| <b>Subject:</b><br><br>COOLANT LEVEL WARNING LIGHT COMES ON | <b>Bulletin No:</b> 01-040/10  |
|   | <b>Last Issued:</b> 07/13/2010 |

## BULLETIN NOTE

- This bulletin supersedes the previous bulletin 01-006/09 issued on 02/10/09. The APPLICABLE MODEL(S)/VINS, REPAIR PROCEDURE, PART(S) and WARRANTY INFORMATION have been revised.
- Changes are noted below in Red beside the change bar.

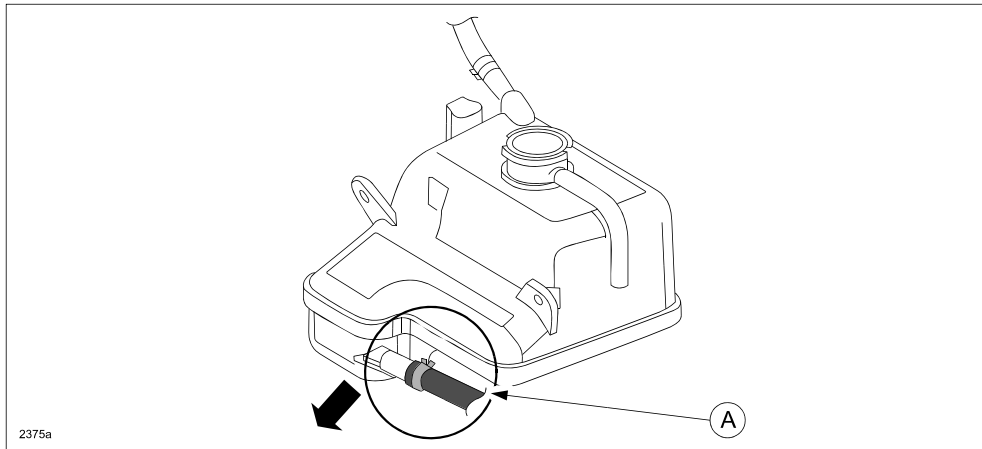
2. Replace the coolant reserve tank (A) with a modified one. Refer to MS3 online service information or Workshop Manual section 01-12 - COOLANT RESERVE TANK REMOVAL/INSTALLATION [13B-MSP].

**NOTE:** When removing the water hose (A) from the reserve tank, remove from the radiator upper tank side first, then remove the reserve tank side. Otherwise the nipple on the radiator upper tank may break.

3. Replace the necessary parts according to this VIN range.
  - For VINs JM1FE\*\*\*\*\* 100000 to 157837 (built before July 1, 2005), replace the tank with sensor.
  - For VINs JM1FE\*\*\*\*\* 157838 to 403405 (built on or after July 1, 2005), replace the tank only.

### Replacement procedure of "tank with sensor"

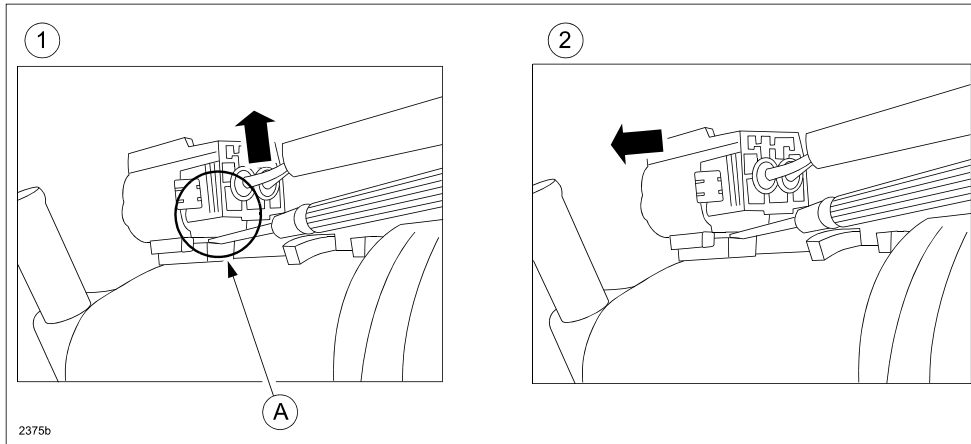
- a. Remove the cooling system cap from the coolant reserve tank; **the cap will be reused.**
- b. Install a new coolant reserve tank (with sensor), then install the coolant system cap.

**Replacement procedure of "tank only"**

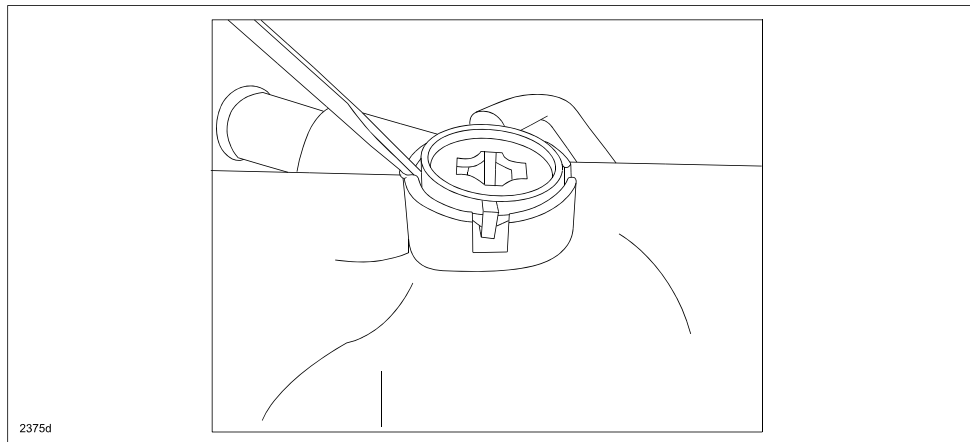
- a. Remove the cooling system cap from the coolant reserve tank; **the cap will be reused.**
- b. Remove the sensor connector from the tank by (1) inserting a flat screwdriver underneath the connector and push up, then (2) slide the connector forward.

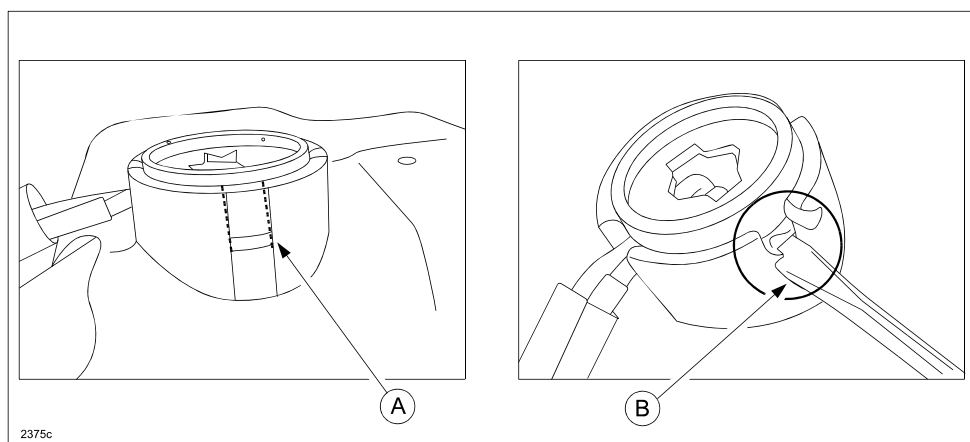
- c. Use a flat screwdriver to pry the sensor loose (on both sides) from the coolant reservoir; the sensor will be reused.

**NOTE:** If the sensor is hard to remove, cut the dotted line (A) as shown (both sides) using cutting pliers, then remove the sensor from the coolant reserve tank using a flat screwdriver (B).
